From: [bruce hain](#)
To: [Uinta Basin Rail Environment](#)
Subject: Attn: Joshua Wayland - Docket No. FD 36284 - COMMENT - UINTA BASIN RAILWAY
Date: Wednesday, September 04, 2019 9:35:29 AM
Attachments: [PINE VALLEY ROUTE AND MILEAGE - EMAIL.png](#)
[Cobble Pass Tunnel EMAIL.png](#)
[DUCHESNE EMAIL.png](#)
[DUCHESNE-ROOSEVELT 25.7MI. EMAIL.png](#)
[ROOSEVELT-VERNAL 29.9 MILES EMAIL.png](#)

COMMENT

UINTA BASIN RAILWAY PROJECT

PINE VALLEY ROUTE

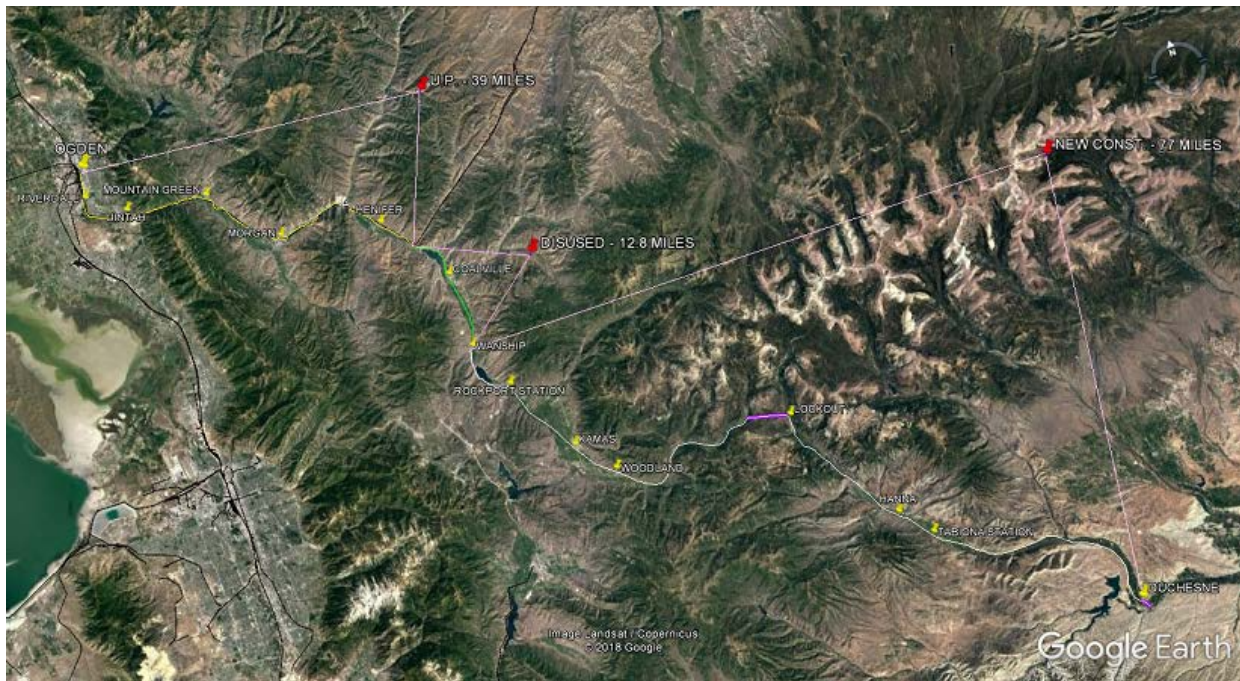
The proposed mixed-use alignment consists of three segments starting with the initial leg out of Ogden over tracks of the Union Pacific - 39 miles - with proposed stations at Riverdale, Uintah, Mountain Green, Morgan and Henefer. The proposed alignment then exits the UP Main Line near the big curve at Echo, beginning the second leg - 12.8 miles - passing over a believed-serviceable grade-separated connection that crosses Route 80 on a curved single-track bridge. This disused 12.8-mile segment would serve proposed stops at Coalville and Wanship where the line would then diverge from the existing disused railroad grade to an **approximately-77-mile** (as fully half the curves haven't been drawn yet) proposed alignment with stops at Rockport Station (a made-up name) Kamas, Woodland, Lookout (another made-up-name) Hanna, Tabiona Sta. (made up) and Duchesne. Two segments needed to reach Roosevelt and an ultimate Vernal terminal station are not included in the picture but are shown below. It is expected the Seven County Infrastructure Coalition would find easy access for their needs somewhere between the proposed stations at Duchesne and Mylon.
